Responsiveness Summary

SeaTac Development aka MasterPark Lot C

Re: Draft Health Consultation – Agreed Order Review
SeaTac Development Site (aka MasterPark Site)
SeaTac, King County, Washington

Ecology responses to DOH draft memo on SeaTac Development Agreed Order and Work Plan exhibit¹:

Attachment A. Figure 2 from Golder Associates report, "On-site Source and Groundwater Investigation Summary – June to November 2007"

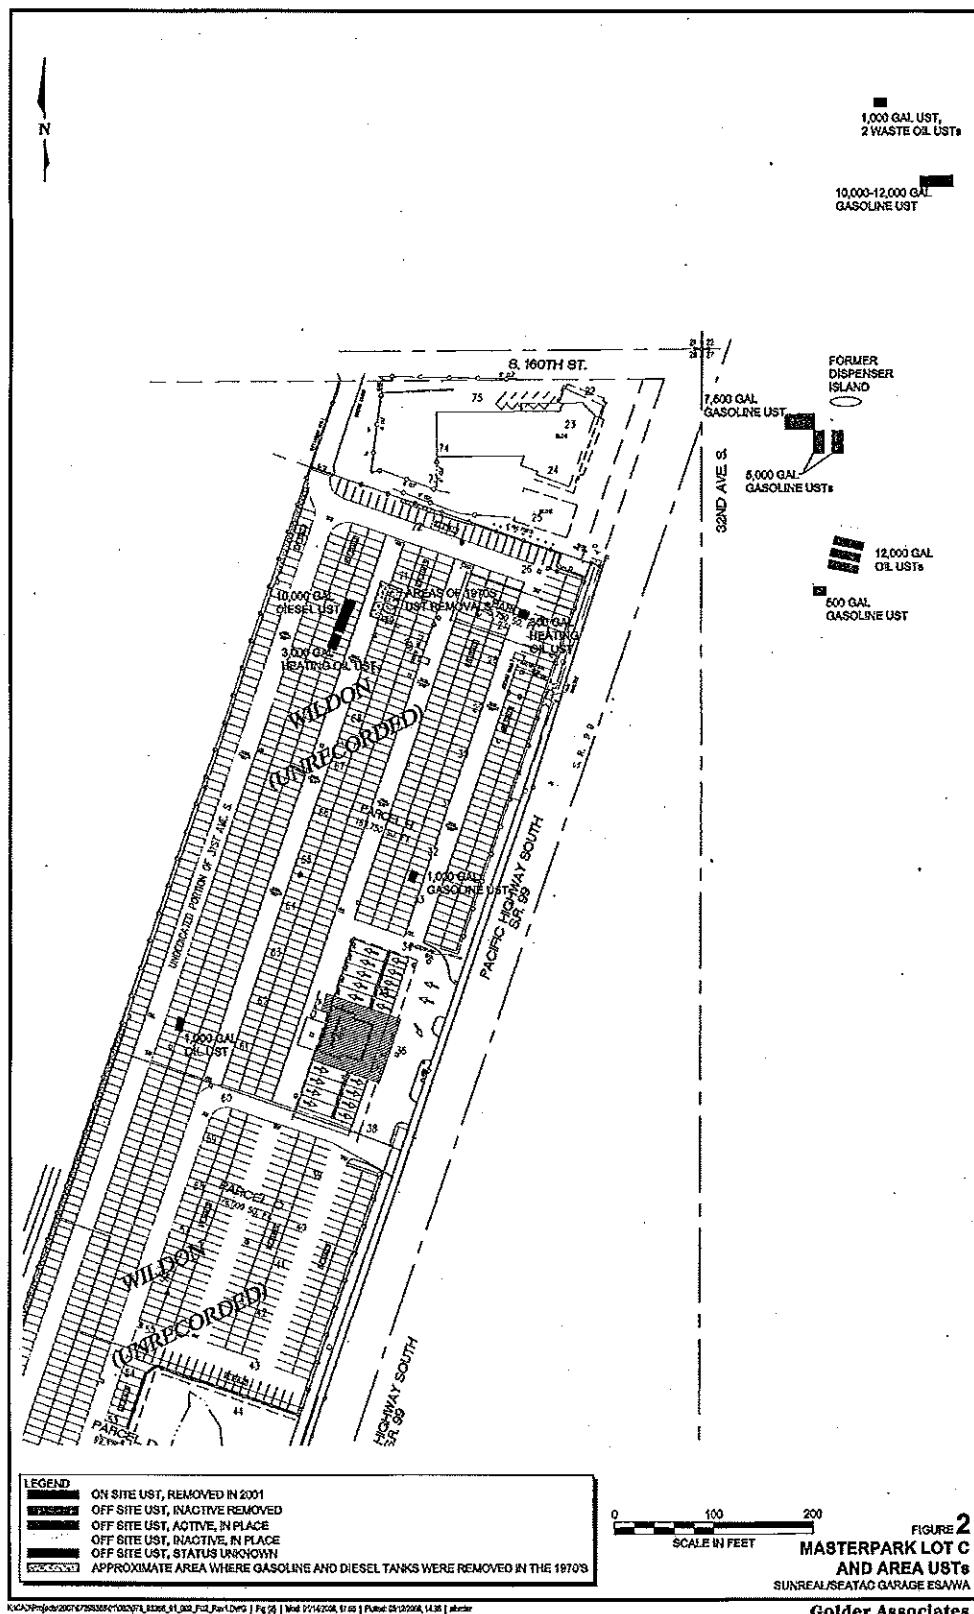
Information provided in the work plan suggests that the soil contamination has been defined (see page 5) so no soil investigation work is planned for the RI. However, no data (e.g., tables, maps, laboratory data sheets) are provided in the work plan to support that conclusion. Given this lack of information about the nature and extent of soil contamination, DOH cannot verify this conclusion nor determine possible health threats. However, the cross section presented in Figure 3 in the work plan does suggest that a potential health threat is possible if a construction or utility worker encountered the gasoline and benzene contaminated soil shown on that figure.

The work done to characterize soil contamination is cited in the Agreed Order. These reports and data therein are available at the Department of Ecology in Central Records. The data and the summary for soil characterization will be incorporated in the final RI/FS report. Based on past subsurface investigations conducted with Ecology oversight, the source is believed to be in a limited zone where former underground storage tanks were located at the north-northeast portion of the property (see Attachment A: Figure 2 from Golder associates report, "On-site Source and Groundwater Investigation Summary – June to November 2007"). Data on soil contamination were collected using several methods including soil borings, test pits, monitoring wells, and geophysical surveys (ground-penetrating radar, magnetometry, and TDEM – Time Domain Electromagnetic Method).
